FORT CALHOUN STATION, UNIT NO. 1

AMENDMENT TO FACILITY OPERATING LICENSE

Amendment No. 114
License No. DPR-40

ATTACHMENT TO LICENSE AMENDMENT NO. 114

RCS PRESS-TEMP LIMITS HEATUP

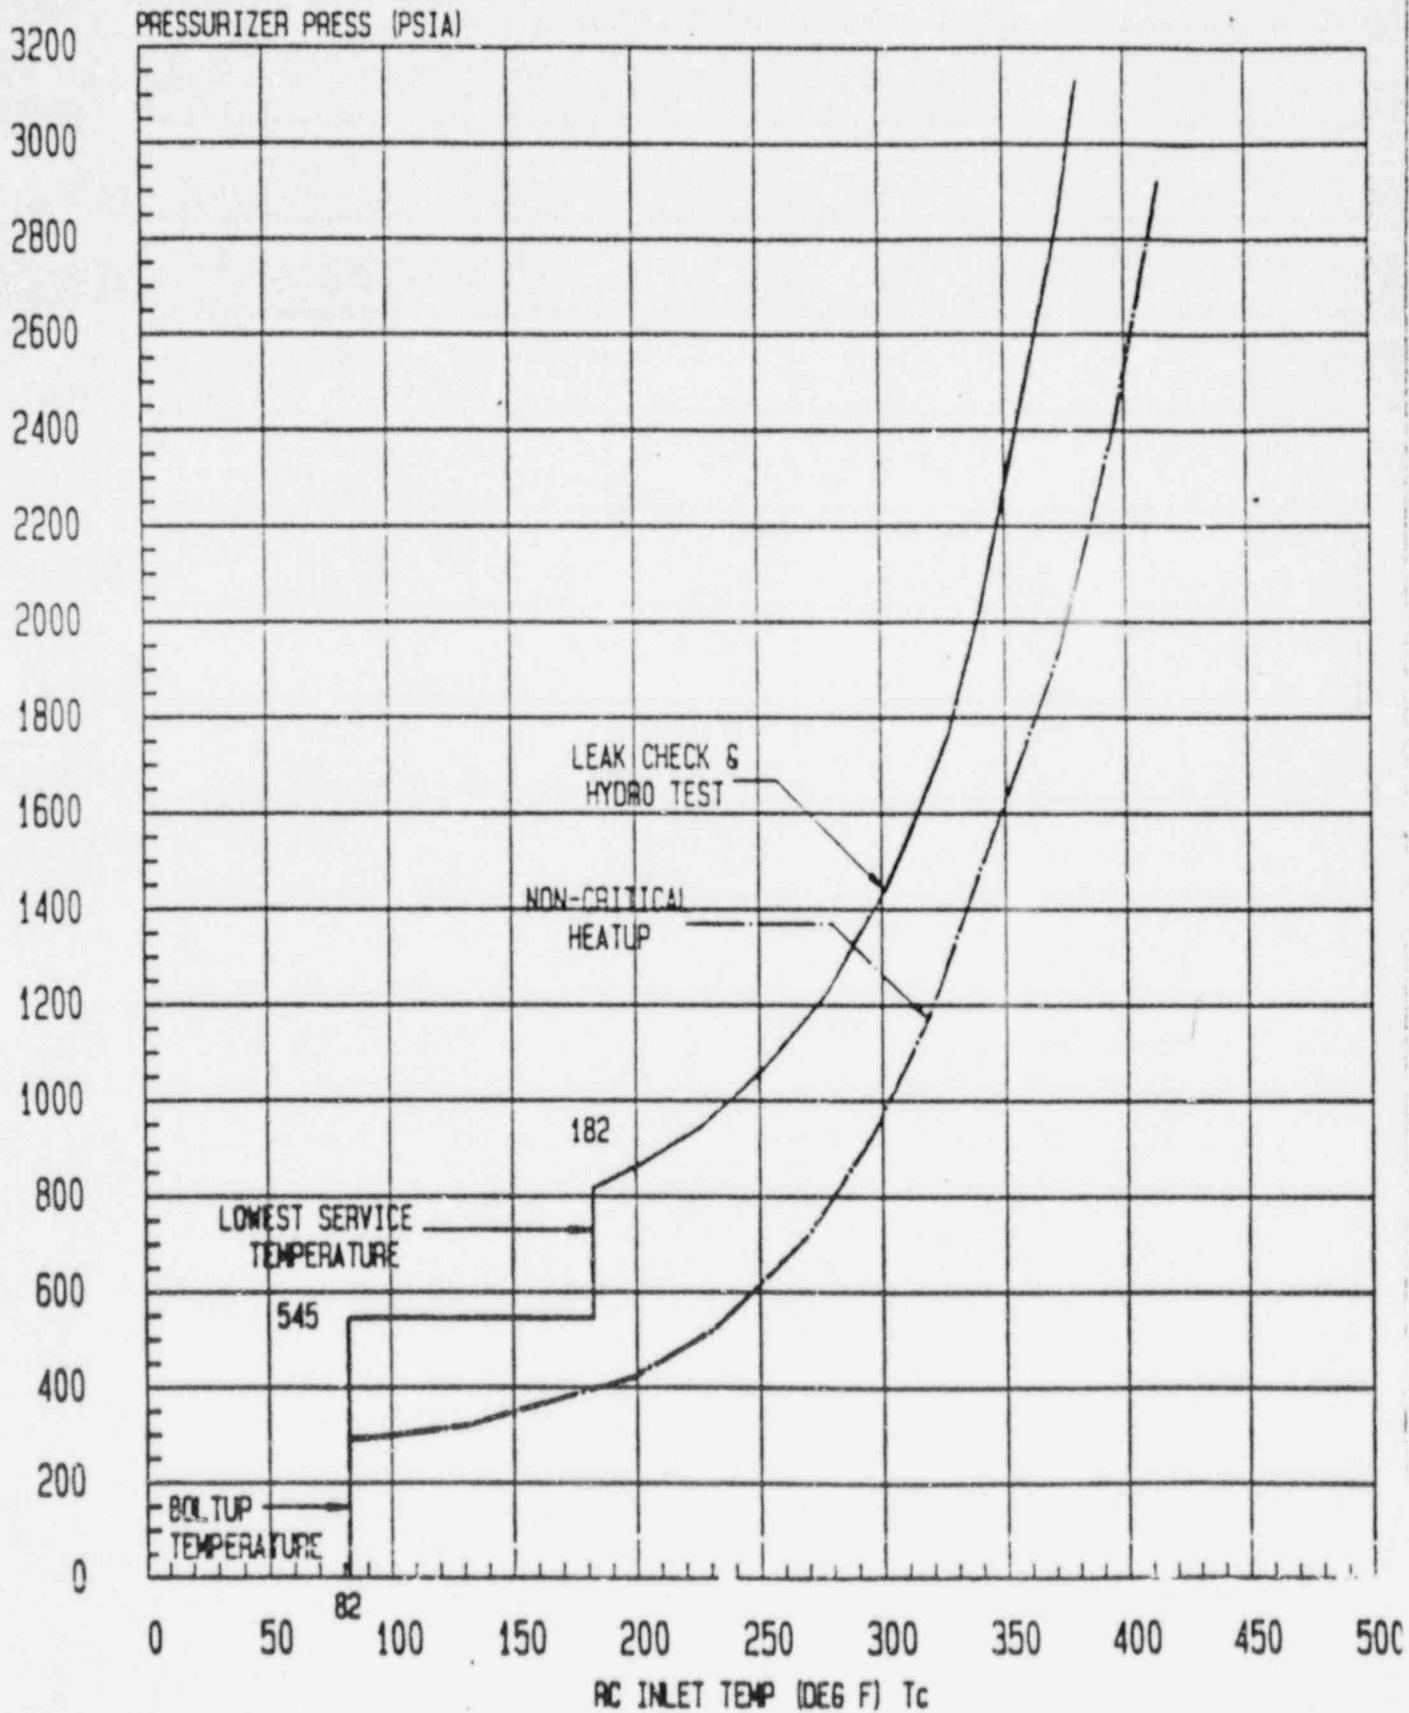
- (c) The limit lines in Figures 2-1A and 2-1B shall be moved parallel to the temperature axis (horizontal) in the direction of increasing temperature a distance equivalent to the transition temperature shift during the period since the curves were last constructed. The boilup temperature limit line shall remain at 82°F as it is set by the NDTT of the reactor vessel flange and not subject to fast neutron flux. The lowest service temperature shall remain at 182°F because components related to this temperature are also not subject to fast neutron flux.

The limit lines in Figures 2-1A and 2-1B are based on the following:

- A. Heatup and Cooldown Curves - From Section III of the ASME Code, Appendix G-2215.

The above equation is applied to the reactor vessel beltline. For plant heatup the thermal stress is opposite in sign from the pressure stress and consideration of a heatup rate would allow for a higher pressure. For heatup it is therefore conservative to consider an isothermal heatup or $K_{IT} = 0$.

RCS PRESS-TEMP LIMITS COOLDOWN

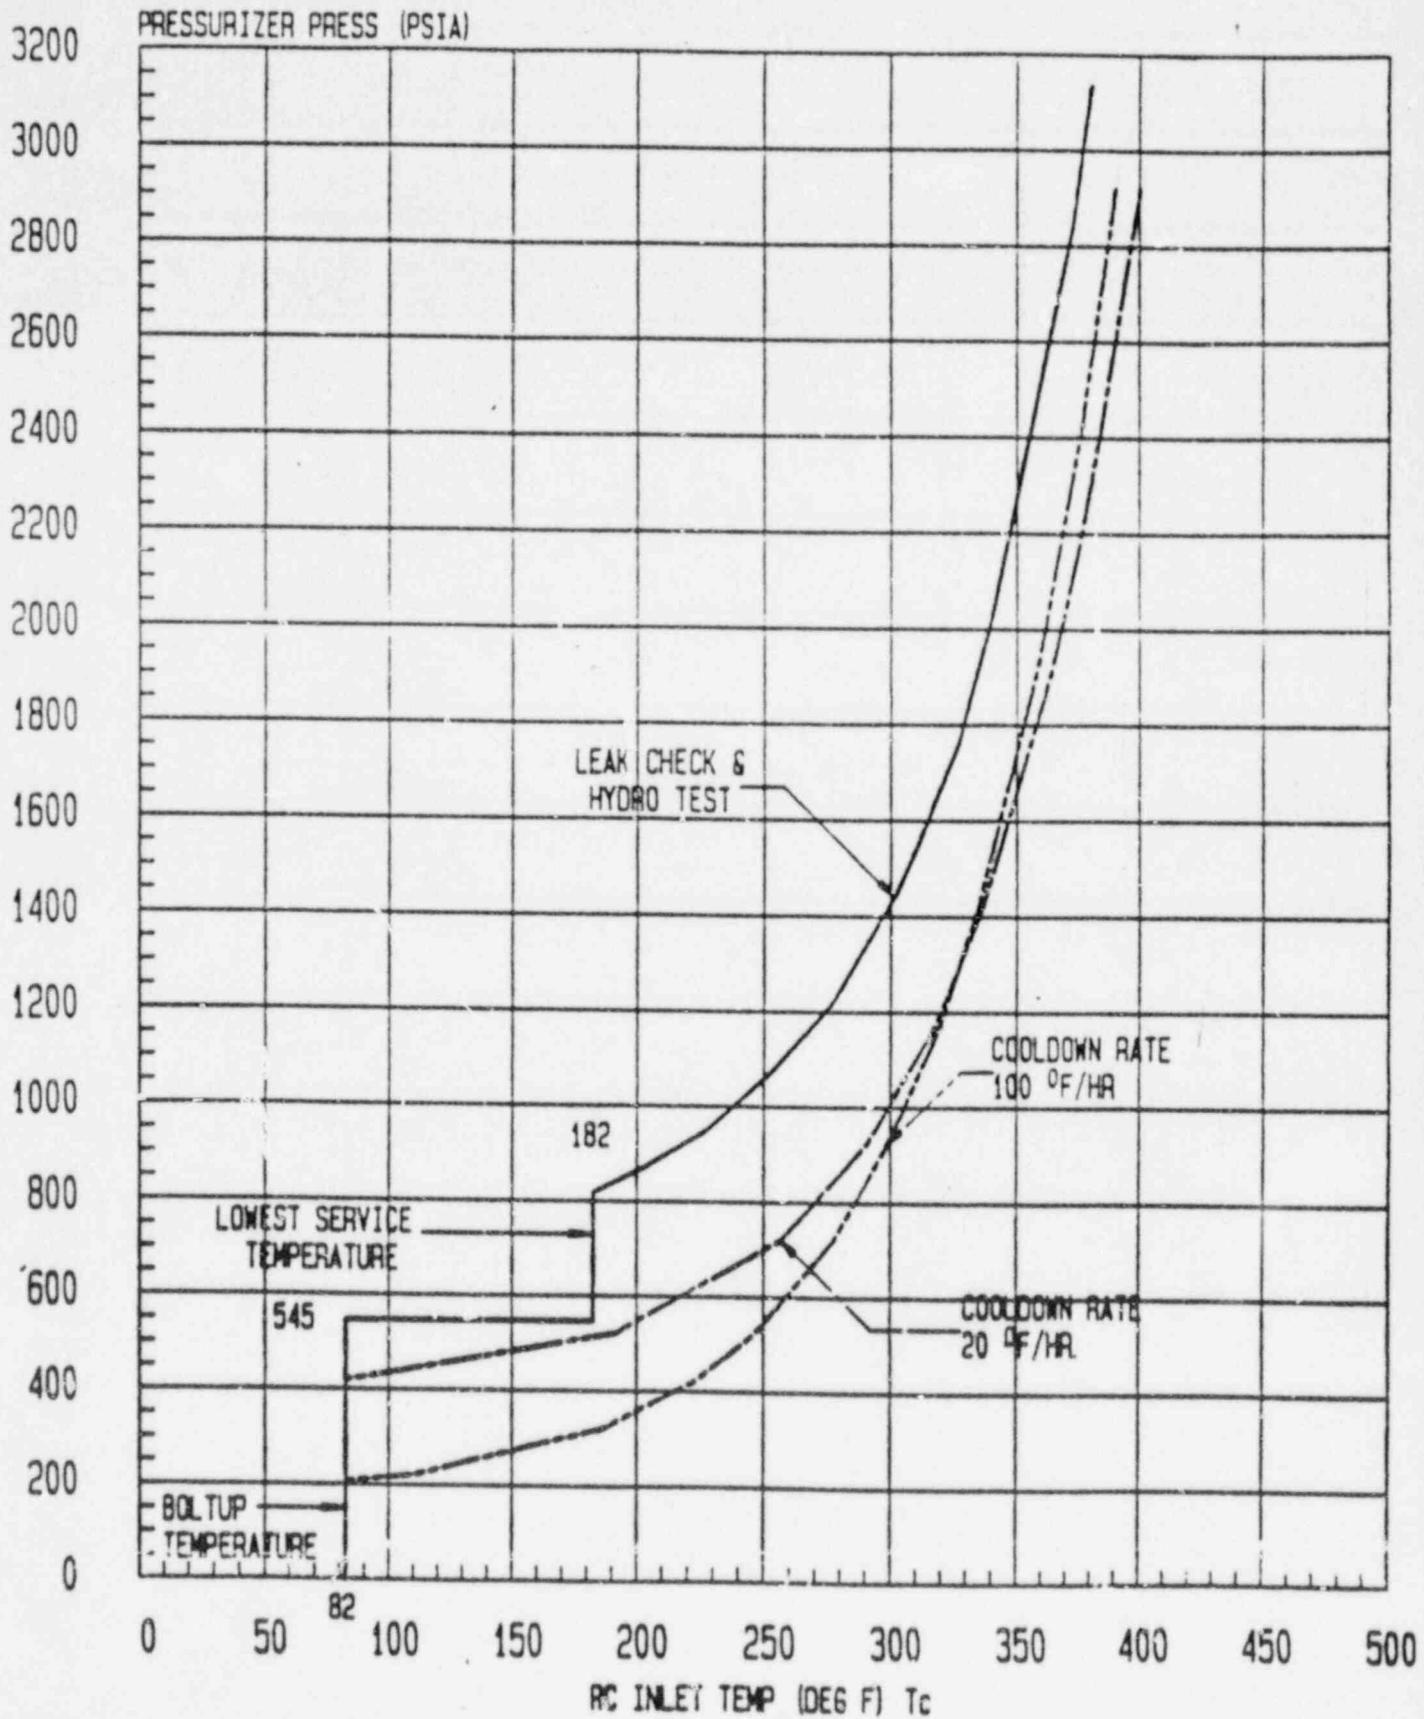
For plant cooldown thermal and pressure stress are additive.
